**RE: Valle Prado Unit 3  
Drainage Report and Grading and Drainage Plans  
Engineer's Stamp Date 3-26-2015 (File: C09D011A)**

Re: Valle Prado Unit 3, Grading and Drainage Plan (C09/D011A)

This letter provides a written response to your comments dated November 25, 2014:

**DRAINAGE REPORT  
FOR  
VALLE PRADO UNIT 3 AT THE TRAILS UNIT 3A  
SUBDIVISION**

VALLE PRADO  
UNIT 3 BASIN MAP

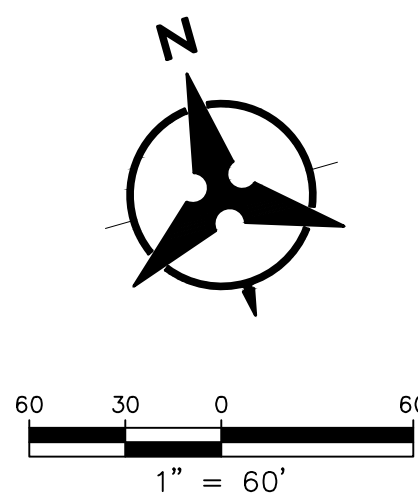
7. *Drainage Report (IV) states Unit 3 is 14.5 acres, but Basin Map shows 9.1 acres. The 14.5 acres is based on the existing Tracts to be subdivided per the Preliminary Plat. Tract C, 7.7 acres, will be subdivided as part of future phases of the Valle Prado development. Basin 1 includes about 2 acres from Tract OS-2 that is not part of the 14.5 acres that is being subdivided to create Valle Prado Unit 3.*

VALLE PRADO UNIT 3 GRADING AND DRAINAGE PLAN			
Design Review Committee	City Engineer Approval	Mo./Day/Yr.	Mo./Day/Yr.
Last Design Update			
City Project No.	Zone Map No.	Sheet	Of
XXXXXX	C-09-Z	1	2

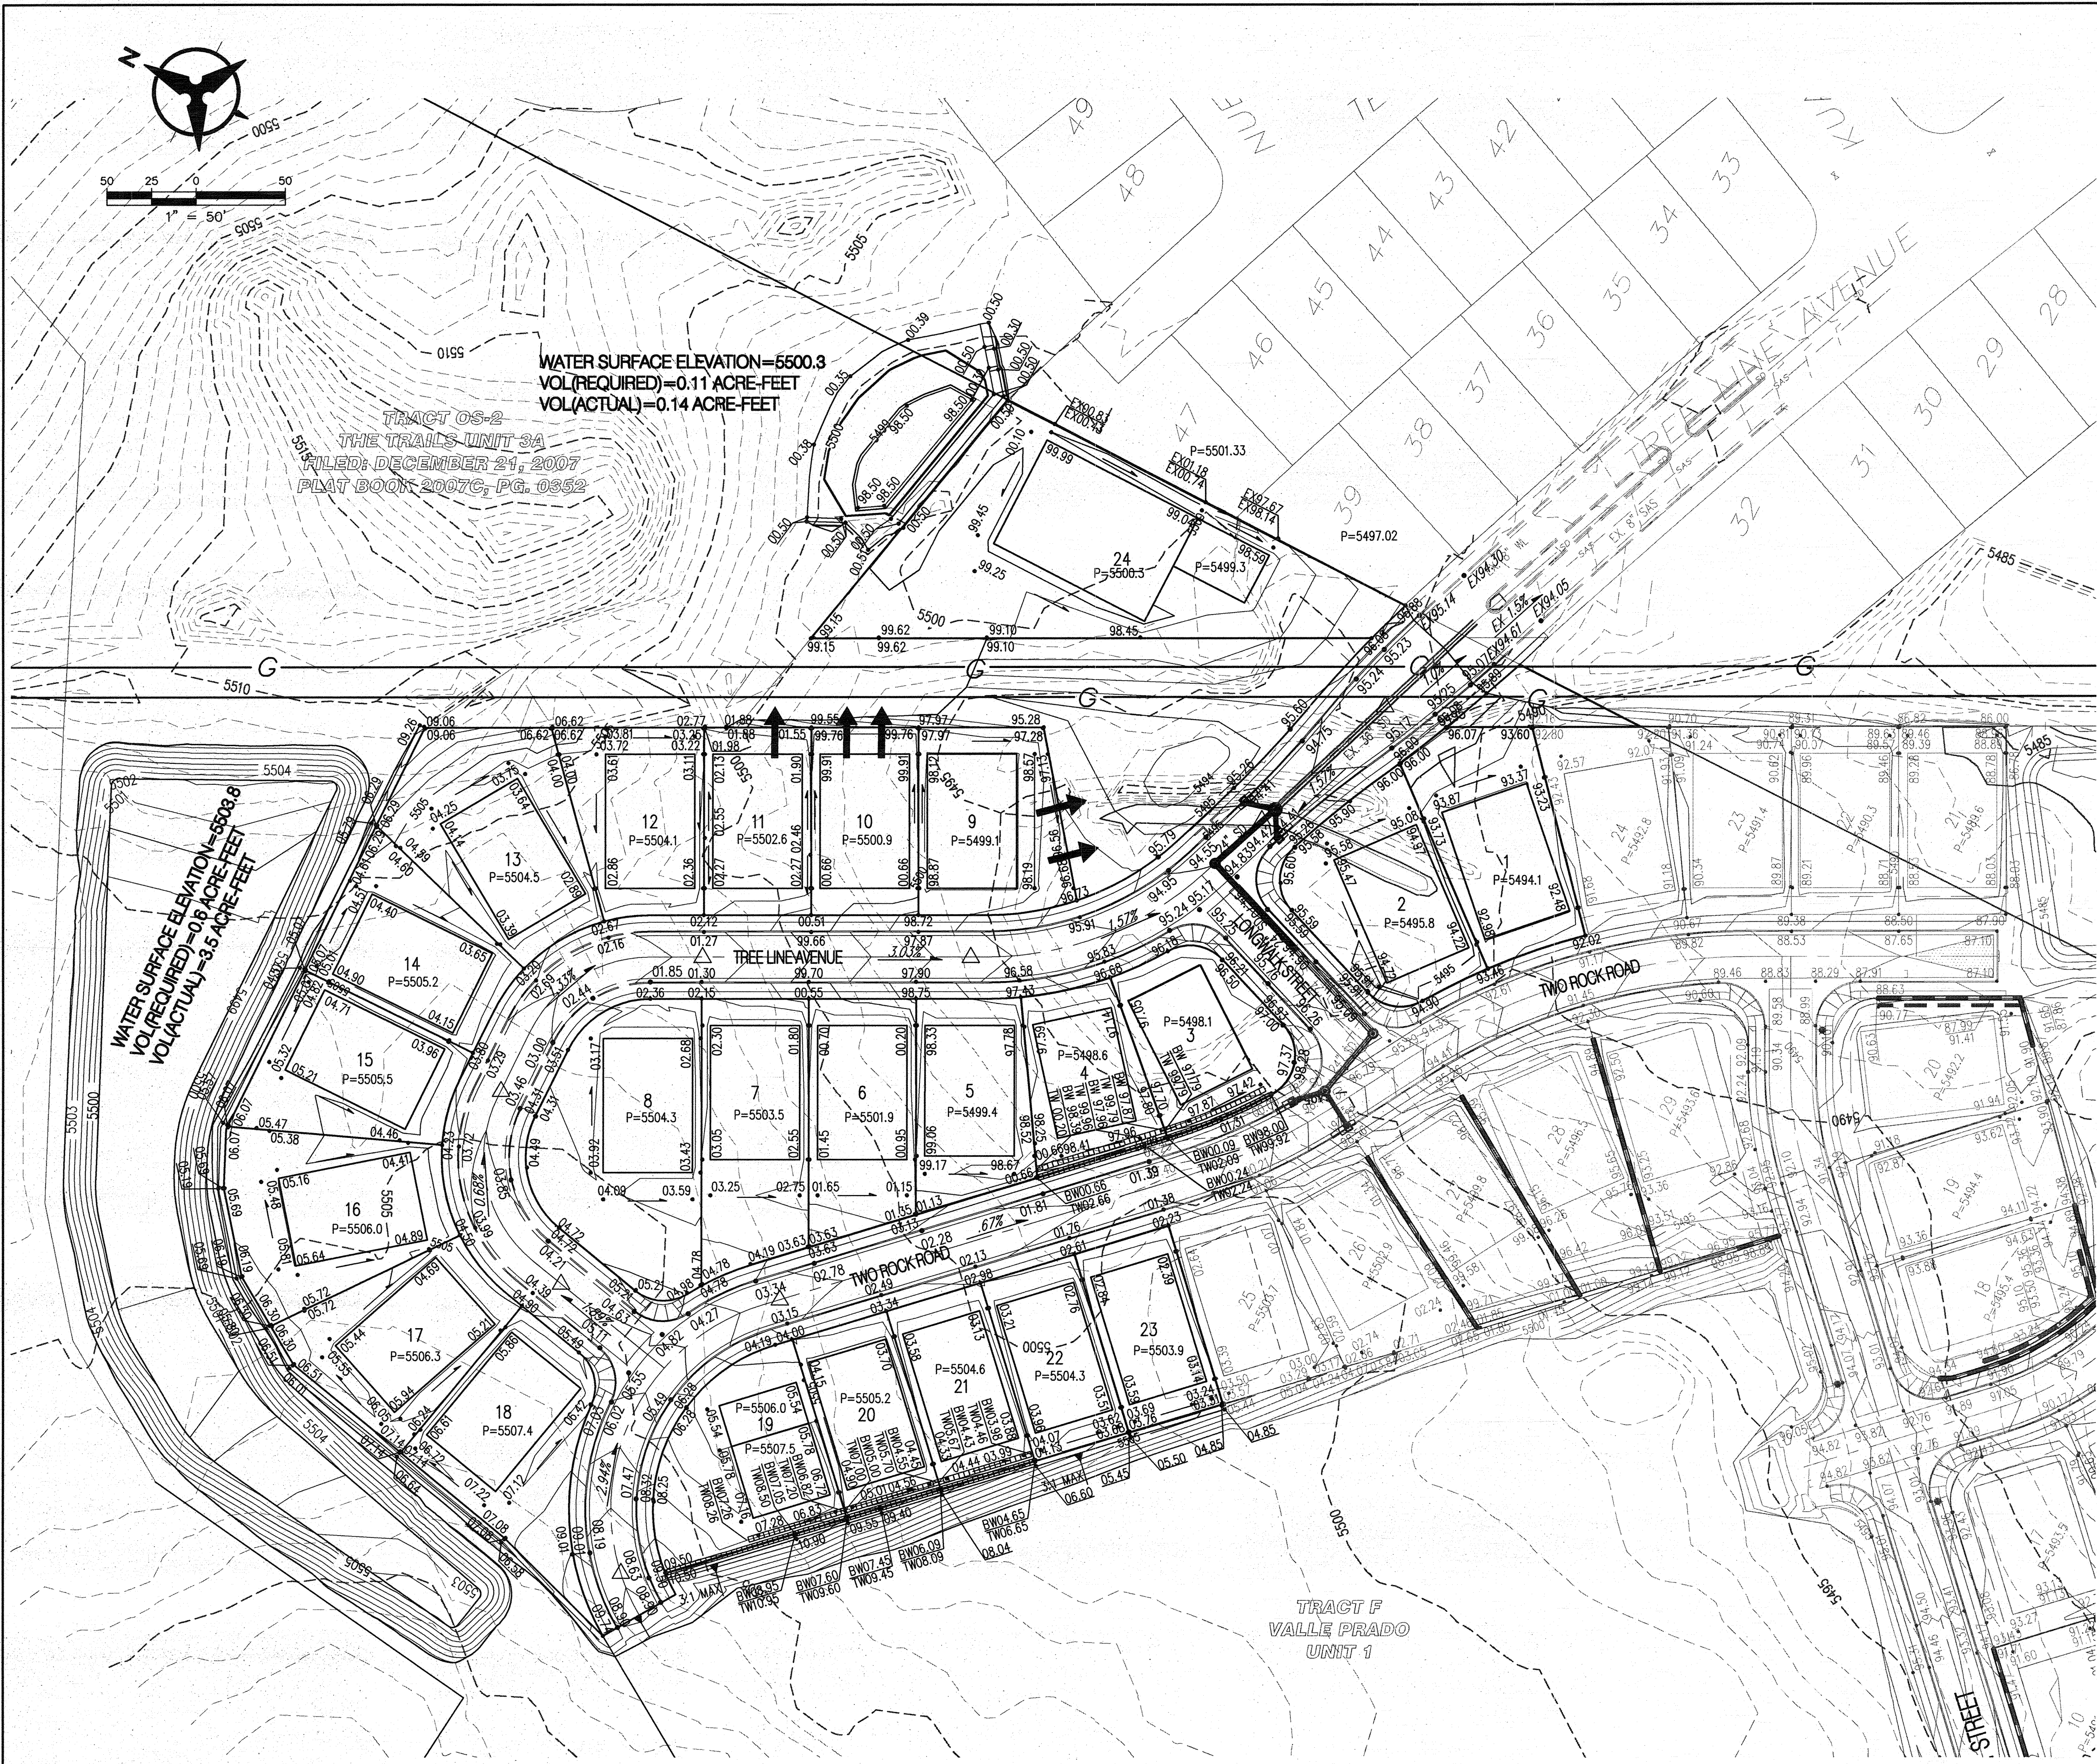
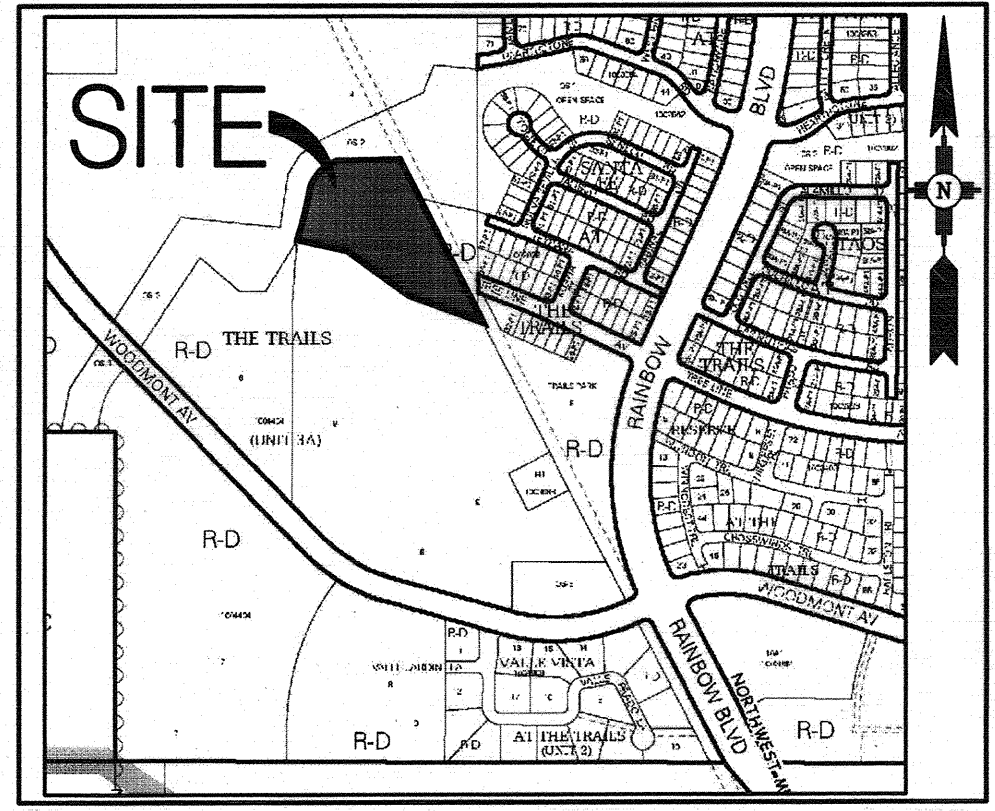
- 1. Approval from the Gas Company is required, as there is some grading and drainage into the easement. Gas Company approval to reference the Engineer's Stamp date. Indicate how far into gas easement, and how deep you will excavate in order to tie into the existing Storm Drain in Tree Line Avenue. The as-builts show that the last sticks of pipe would need to be removed. **The requirement for Gas Company approval is noted. The existing 36" storm drain extends about 65' west of the 50' gas easement. Connection to the western terminus (per field design survey information) of the existing storm drain is at MH 20 per the Inlet and Storm Drain Network Map. Therefore, there will be no excavation required within the gas easement to tie to the existing storm drain.***

- 2. Tract OS-2 seems to have historically drained thru Lot 24. Wall on North side of lot needs to allow historic flows to pass. The G&D Plan shows that runoff is directed towards the east side of the lot, which may impact adjacent Lots 39 and 47. What are the pad elevations of these lots? Show grades beyond property line. Is there a wall? It would be preferable for offsite flows to drain to gas easement side. **A small retention pond has been added on Tract OS-2 to capture the historic flows that impact Lot 24. The grading plan matches the existing wall grades on the west side (Valle Prado side) of the wall along Santa Fe at the Trails Lots 39 and 47. As-built elevations from the grading and drainage certification for Lots 39 and 47 have been added to the grading plan.***

3. *Most of Lots 9, 10 and 11 drain to gas easement as opposed to Tract A or Tree Line Avenue. Most of Lots 10 and 11 drain to the gas easement. Lot 9 grading has been revised to drain to Tract A area outside the gas easement.*

5. *Can a retaining wall be avoided on Lots 3 & 4? The rear yard retaining wall on Lots 3 & 4 is necessary due to the existing ground elevation differential between Two Rock Road and Tree Line Avenue and the location of basalt in Two Rock Road behind Lots 3 and 4. In addition, Tree Line Avenue needs to be lower than Two Rock Road at Longwalk Street to direct runoff to the sump in Tree Line Avenue. See additional grades provided on revised grading plan.*

6. *Why is the grade raised to 5510' South of Lots 19, 20 and 21? How does this fit in with the future plans for the extension of Two Rock Road to the future Sandmark Road and the Future Basin 3 (from Unit 1&2 Drainage Report)? The 5510' elevation is based on the conceptual grading plan for future lots that will back to Lots 19-21. The conceptual grading plan is based on depth to basalt for the future extension of Sandmark and Two Rock Roads and the lots that front Sandmark Road.*

8. *What is the datum difference in order to compare earlier and adjacent work orders?* **Approximately 2.7 feet.**
9. *Show existing flowline elevations and slopes where Tree Line ties into the existing at Santa Fe at the Trails.* **The existing information has been added.**
